**STAFF REPORT: JUNE 9, 2021 MEETING**

**ADDRESS: 200 EDMUND PLACE**

**HISTORIC DISTRICT: BRUSH PARK**

**SCOPE OF WORK: REVISION OF PREVIOUSLY-APPROVED, MULTI-FAMILY BUILDING DESIGN (UNAPPROVED WORK COMPLETED/IN-PROGRESS WITHOUT PERMIT)**

*The proposed revised elevation, per submitted drawing A3.1.1. The proposed type brick “BR-1” is the same on all sides of the building. Notice the markedly inconsistent parapet heights (the dimension between the tops of the highest windows, and the tops of each mass).*

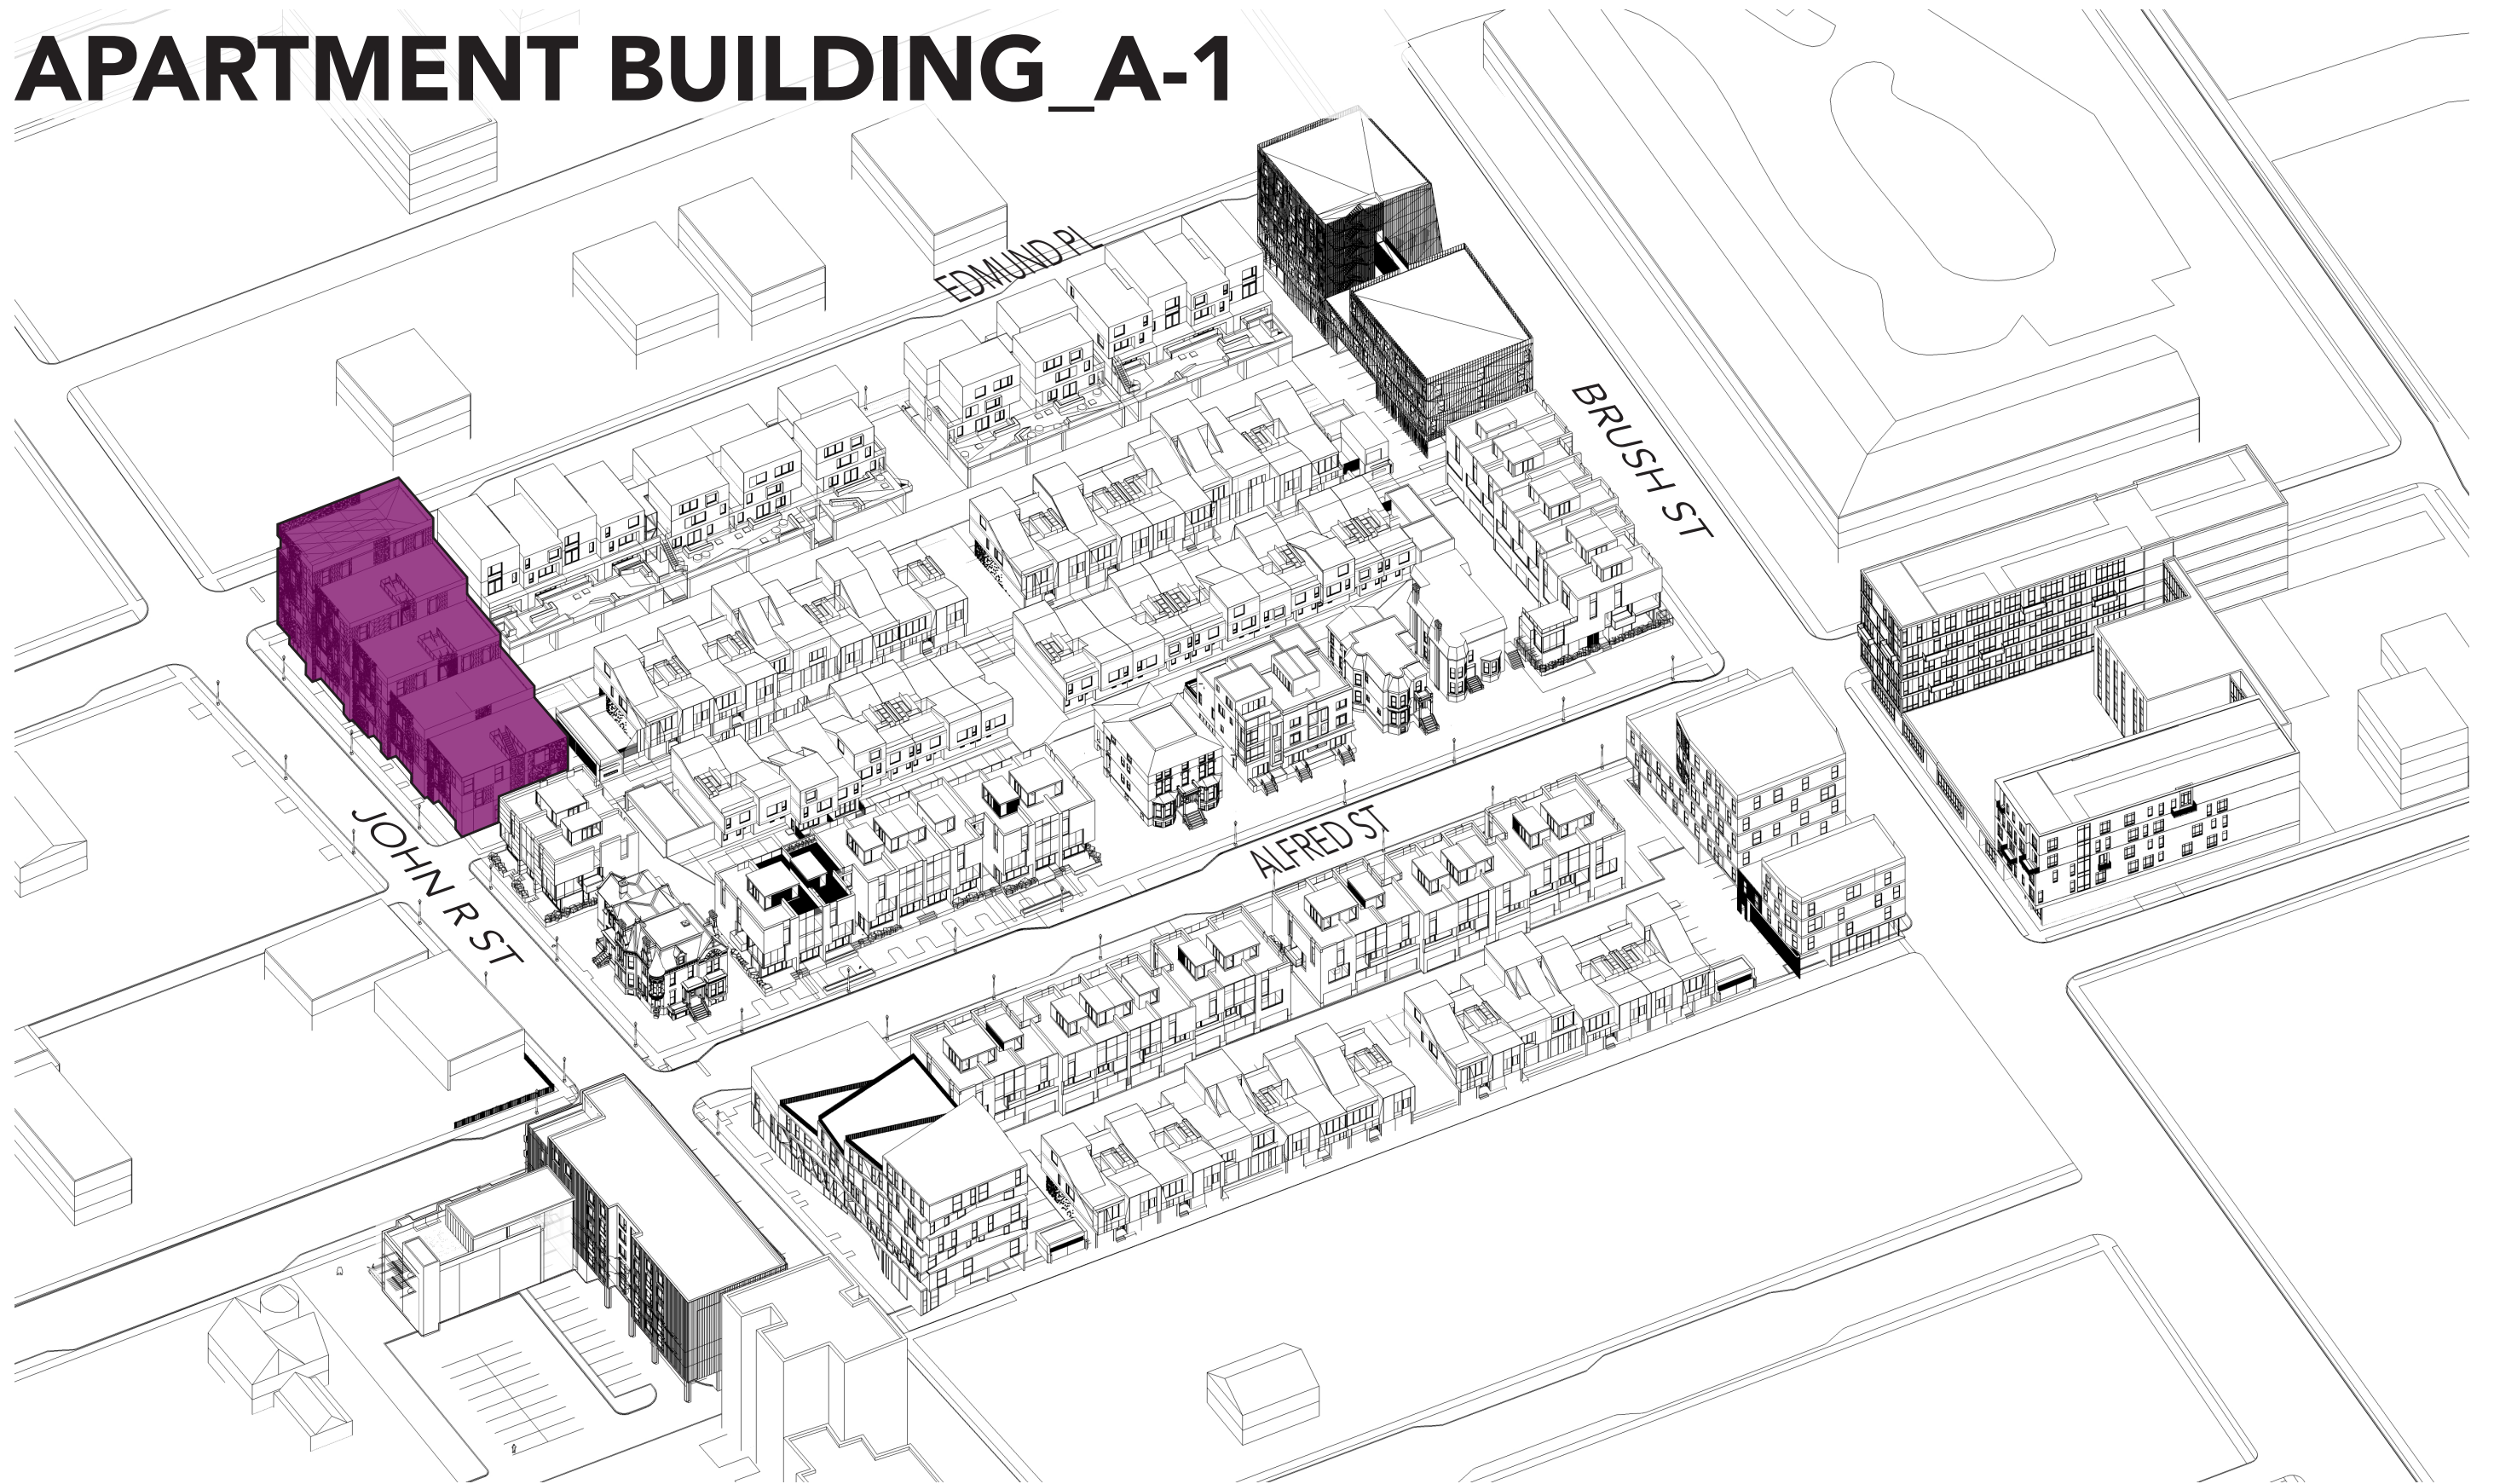
- **Revision to a five-story building, and changes to parapet height in the "step-down" masses.** The original design gave the first four "masses," or "buildings" the same parapet height, with the exception of the final and fifth "mass" at the alley. The redesign forces an awkward workaround in an attempt to preserve this consistent rhythm. Because the first two masses are now both five-story buildings, the

parapet of the second mass is given a “haircut” to create an artificial “step-down” effect imitating the original design. The overall effect is a jumbled composition at the roofline which suffers in comparison to the originally approved design. Per the Elements of Design, #21 (*Symmetric or asymmetric appearance*), HDAB writes that “asymmetrical but balanced compositions are common.” The new composition is asymmetrical, but unbalanced.

- Re-incorporate substantial brick texturing or other articulation, acceptable to staff and per Commission guidance, to introduce the texture and complexity expected by the District’s Elements of Design, specifically Elements 8, 10, 19, and 22.
- Give additional prominence to the Edmund Place façade to match the prominence of the John R façade, acceptable to staff and per Commission guidance, per Elements 21 and 22
- Create a visually consistent step-down at the parapet level, acceptable to staff and per Commission guidance, to preserve the balance and regularity of the originally approved design, per Elements 21 and 22

# APARTMENT BUILDING\_A-1\_BLOCK CONTEXT - ORIGINAL DESIGN

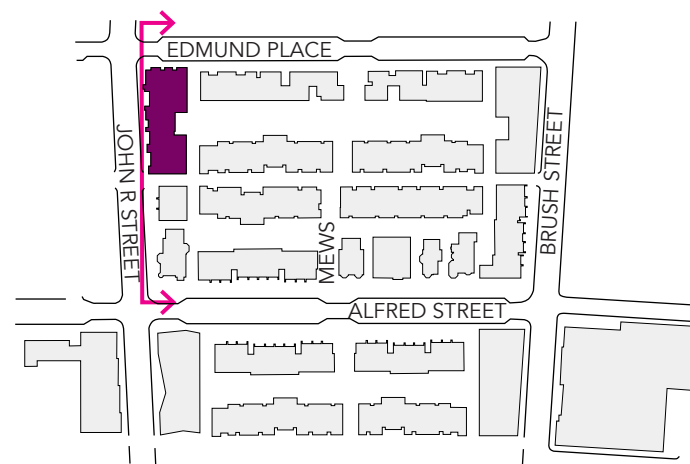
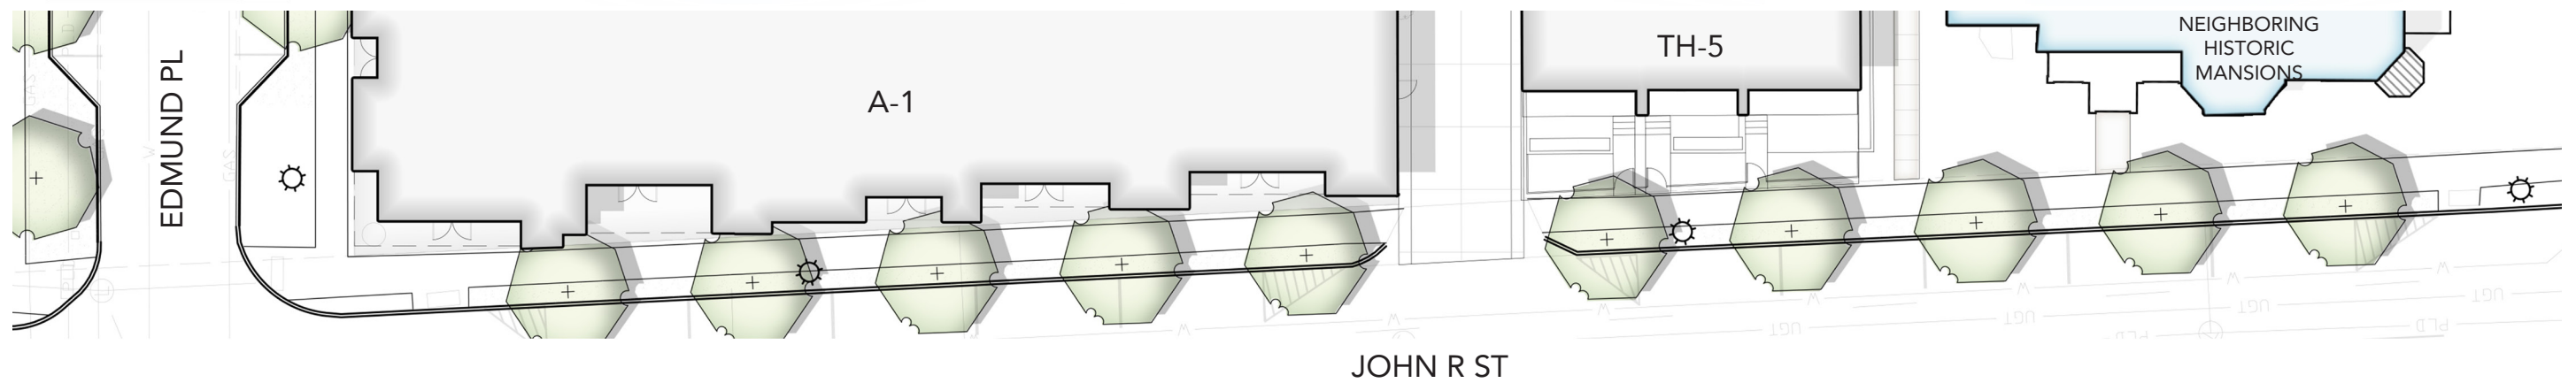
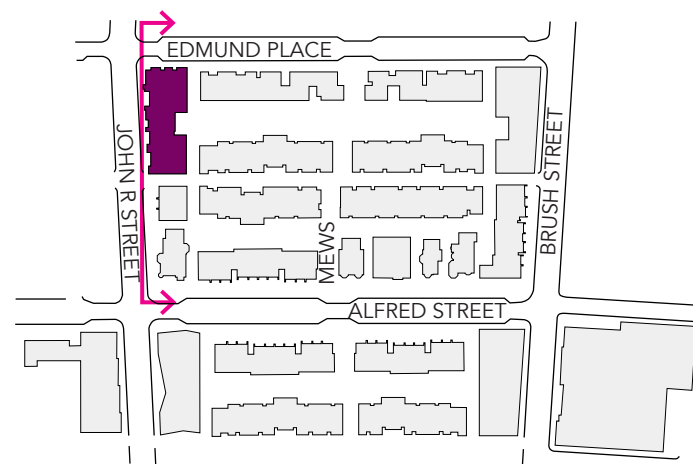
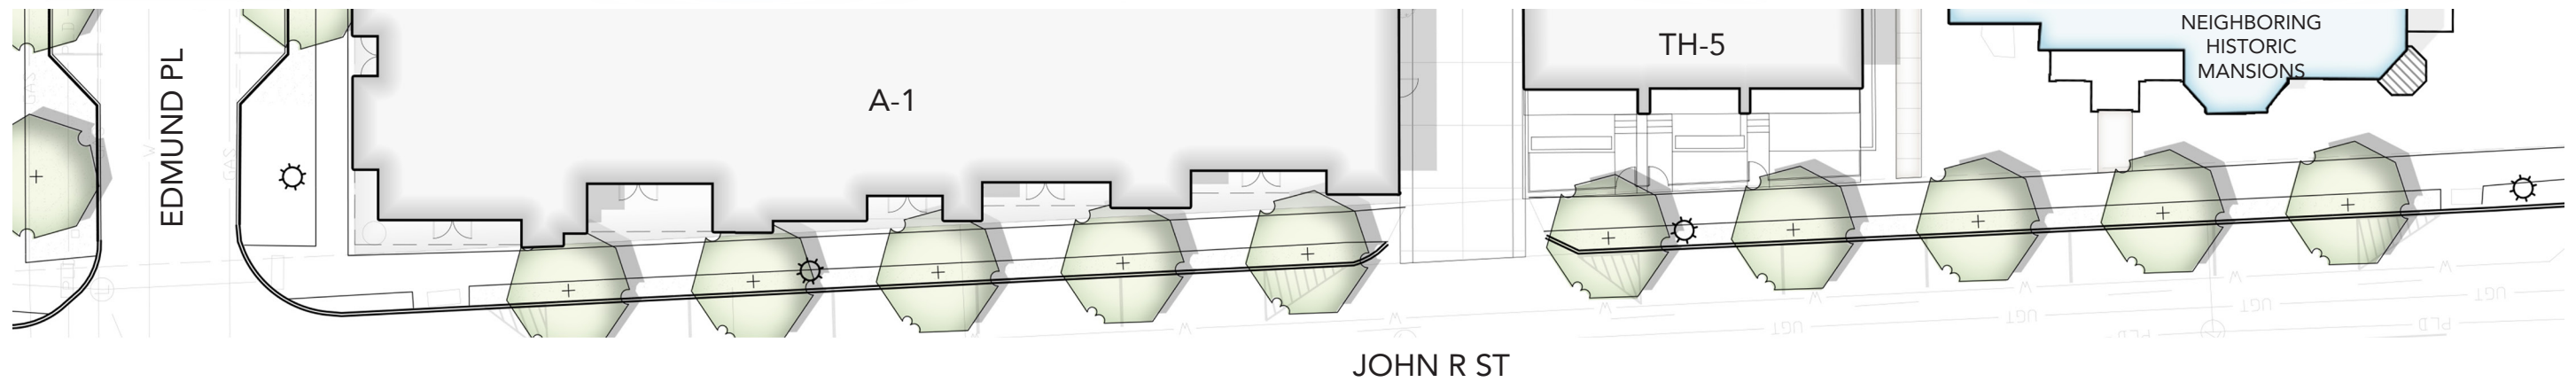
- **Hierarchy of Elevations.** The original design gave substantial and robust character to the primary elevations at John R and Edmund Place, an appropriate and vital reinterpretation of the district's historic character at an exceedingly prominent intersection. As redesigned and partially completed, it is hard to walk around the building and understand which elevations are primary and which are secondary. All appear to be likely to express the same flat, gray brick character. Addressing the brick texture issue outlined above would substantially mitigate this issue.

## Relationship of textures (#8)

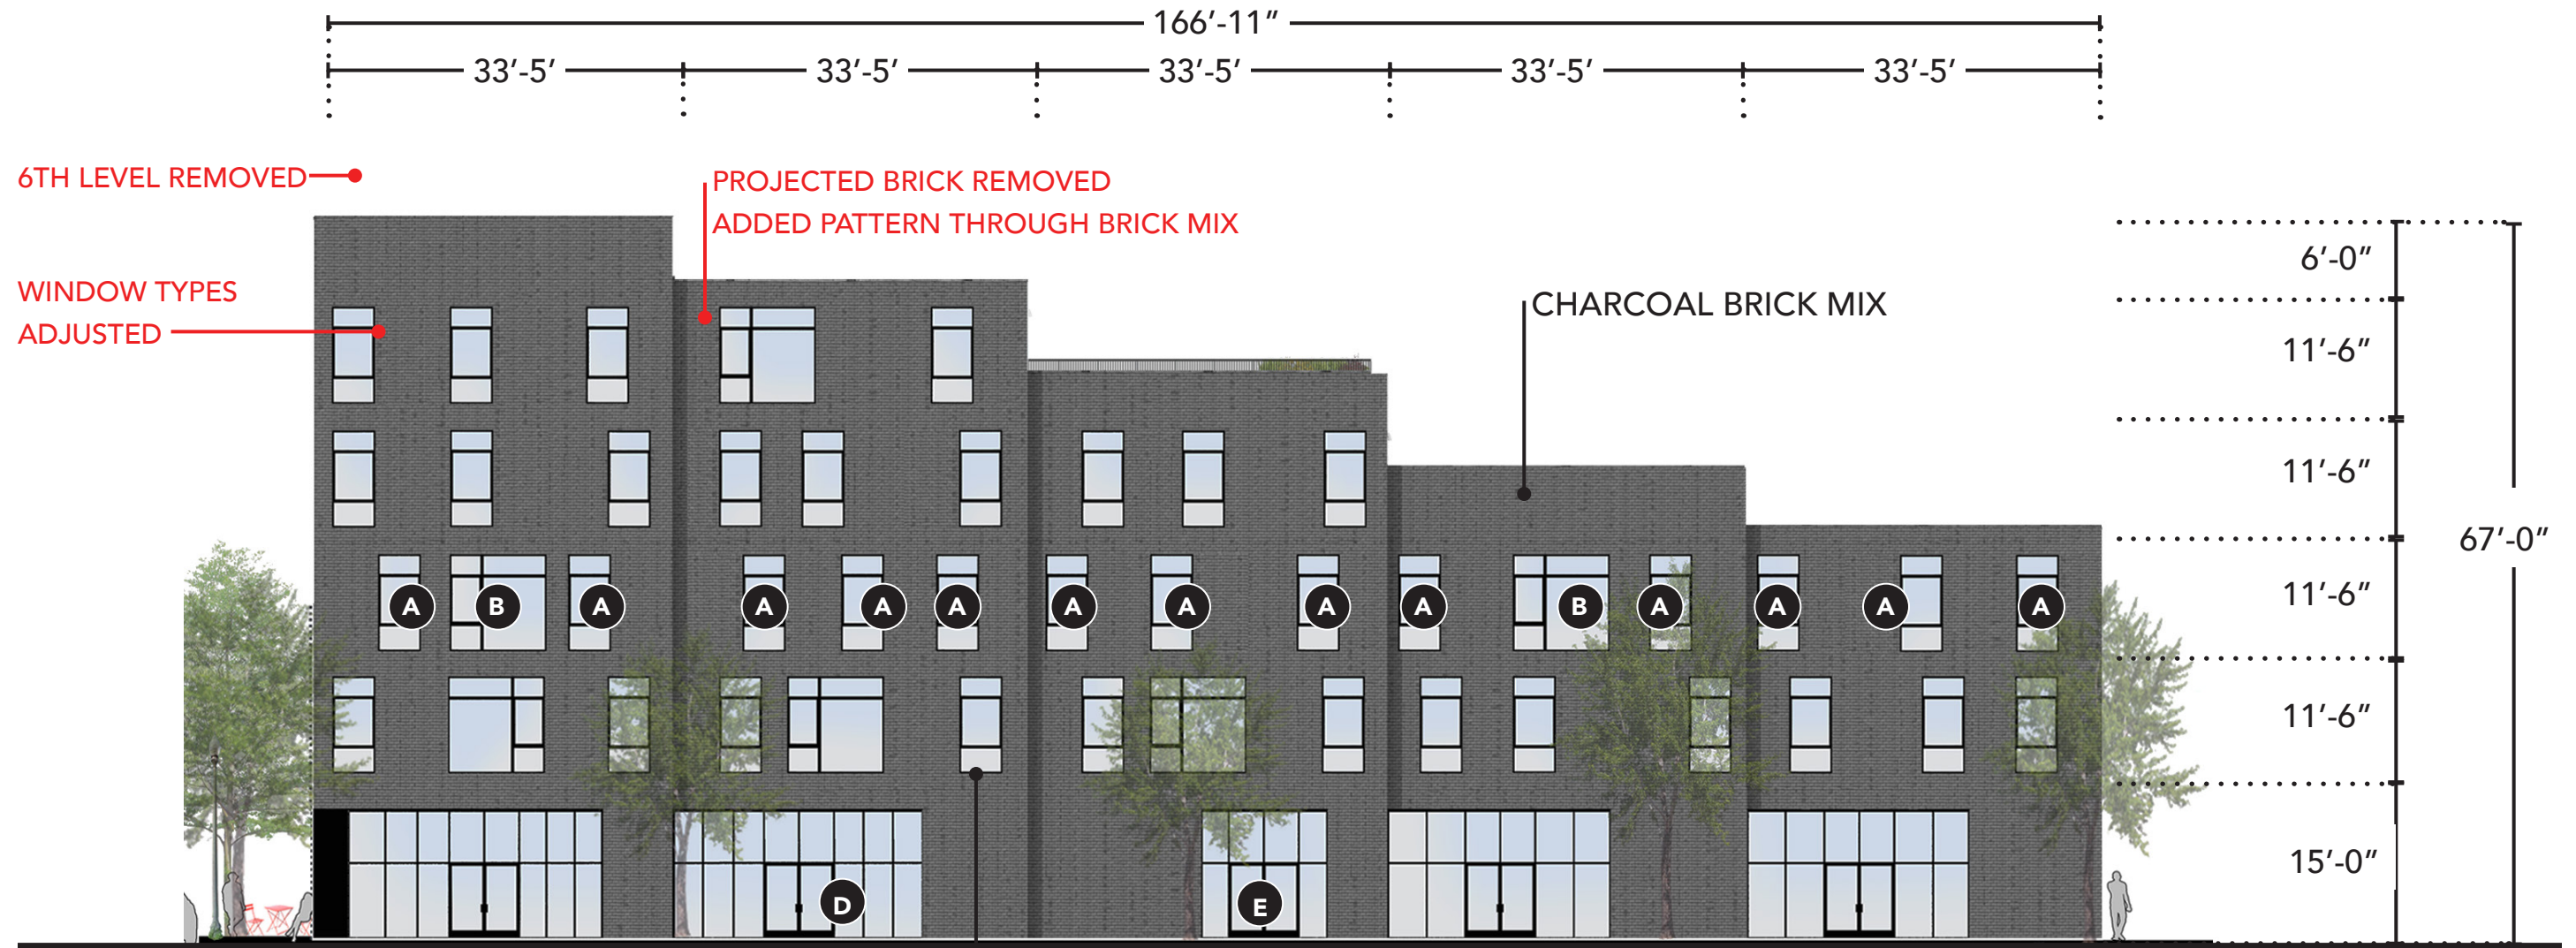
- **Brick.** The proposed “variegated brick,” as a substitute for the dramatic textural waves of projecting brick approved by the Commission in 2016, is unconvincing. In the original application, the applicant specifically (and correctly) identified the textured brick as playing a critical role in responding to several Elements of Design for the Brush Park Historic District. For Element #8 (*Relationship of textures*), the applicant argued that the brick pattern provides architectural detail and texture across the façade” and that “the gradation of projected brick to flush standard brick creates contrast to emphasize critical edges.” Per Element #10, (*Relationship of architectural details*), “Variation in brick detailing provides architectural interest and façade relief.” Then, for Element #19 (*Degree of complexity within the facades*), “Detailed brick patterning creates complexity in shadow lines and material texture.” Finally, responding to Element #22 (*General Environmental Character*), the applicant in their original application stated that “Brick is utilized in a contemporary application to create architectural detail and contrast.” All of these attributes and character-defining elements have been lost in the redesign. Staff recommends that an alternate design reintroducing complexity and shadow into the primary façades, consistent with other recent HDC approvals and projects in the District, be required in order to align with the District's Elements of Design. Potentially, this could be accomplished by needling additional distinctive colored bricks into the field mix to reproduce the splashes of intensity and texture found at each mass in the original design.

The applicant's original arguments (page from 2016 application) show the importance assigned to the projecting brick pattern, which was used to satisfy several Elements of Design. The "variegated brick" effect now proposed in the current redesign is nearly indistinguishable from the "background" brick in the original 2016 design. Staff agrees with the original points presented here.
